Swedish Radiation Safety Authority

Technical Note

2015:41

Hydrogeological aspects of future
human actions for a repository
at Forsmark

Figure 11: Residual hydraulic-head drawdown at the level 450 m.b.s.l. (top) at time of full backfill saturation, and (bottom) two years after full saturation, and (c) six years after full saturation (from SKB R-10-18, Figures 7-51, 7-52 and 7-53).

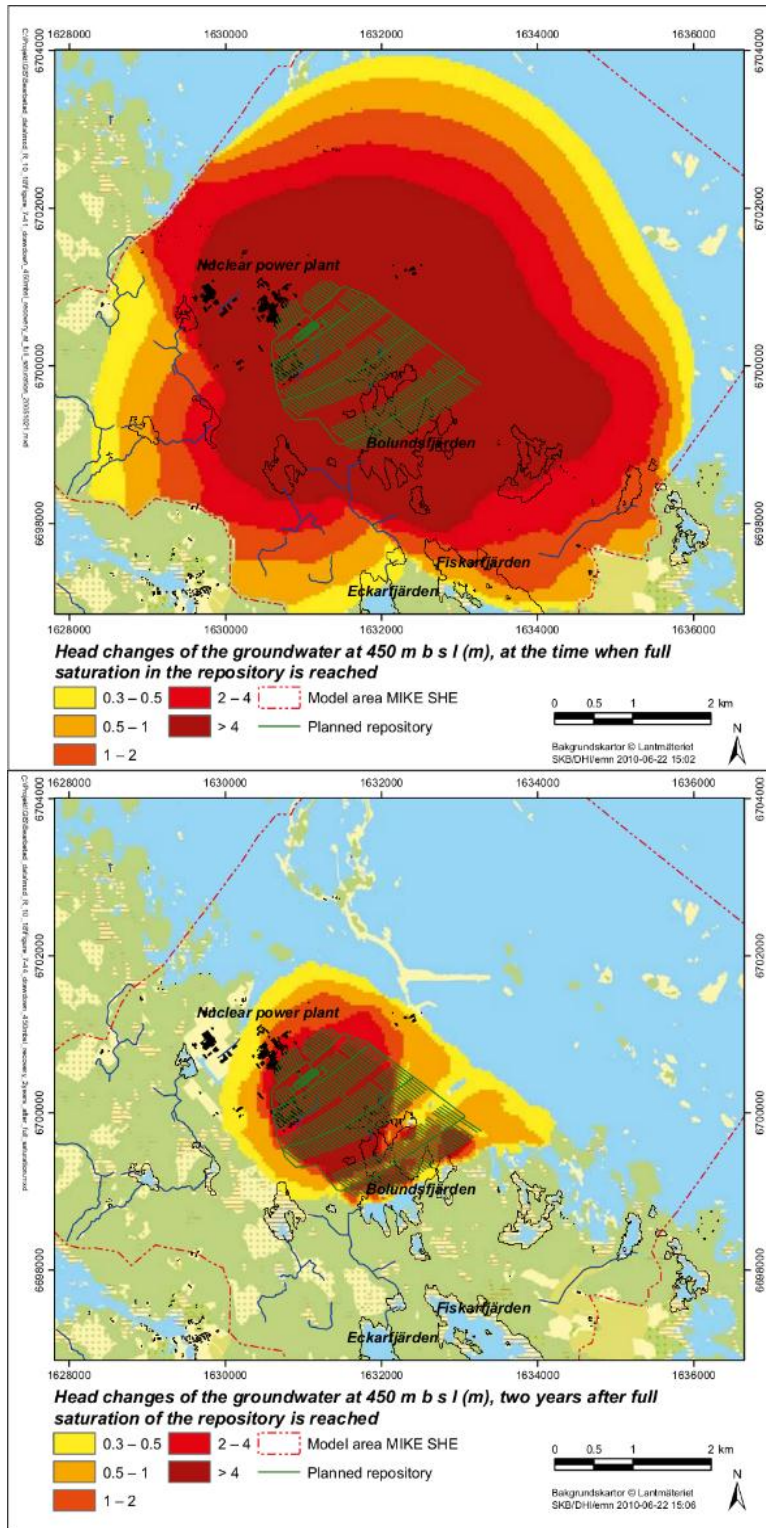
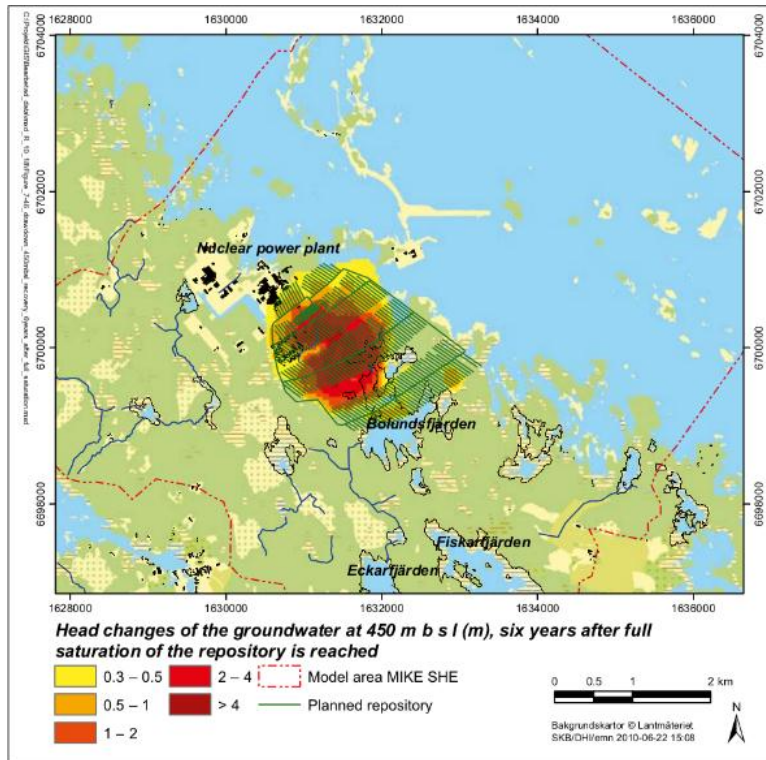
The predicted groundwater recovery time of “a few years “ as stated in the abstract of the report by Mårtensson and Gustafsson (2010) can be regarded as a misstatement, as the presented results show that recovery is incomplete after six years. A more reasonable description of the results would be around ten years.
